3008
 Mallinckrodt 4/16/60
 Proj 5-8
 D/c 70-36

Request for approval of new storage fac at Hematite
 for material enriched @ 5%

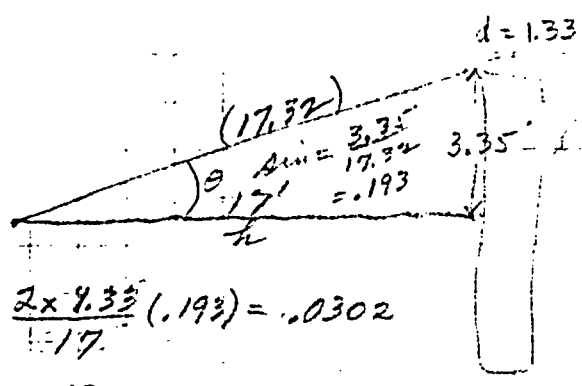
$$\Omega = \frac{2 \times 4.32 \times (0.193)}{17} = .0302$$

$$\Omega_f = \frac{.0302}{4\pi} = .0024$$

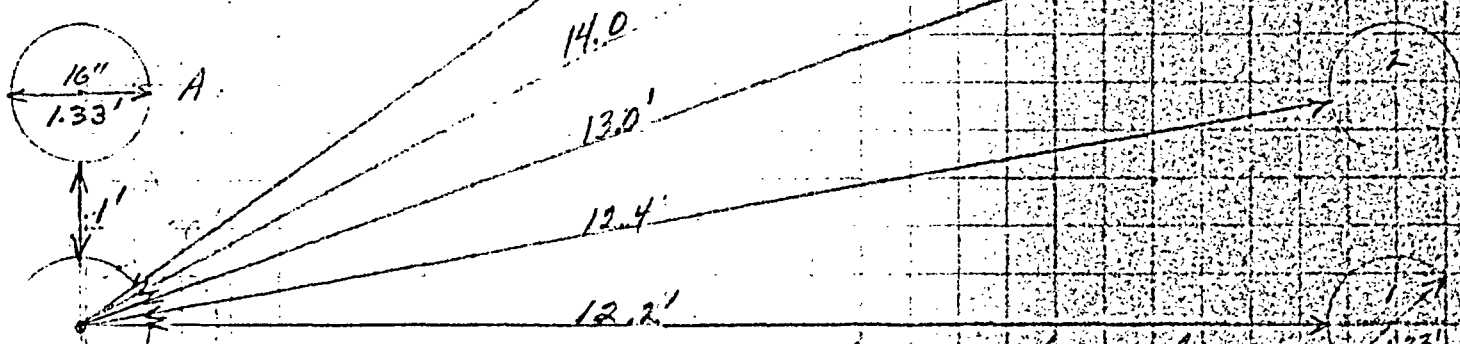
Note - consider L, ht. of column = $4 \times 20'' = 80'' = 6.7'$

$$\epsilon_B = \sigma_A = \frac{\epsilon t \epsilon}{d} = \frac{1'}{1.33} = 0.75$$

$$\lambda_A = \frac{\text{length}}{d} = \frac{6.7}{1.33} = 5.05$$

$$\Omega = .078$$
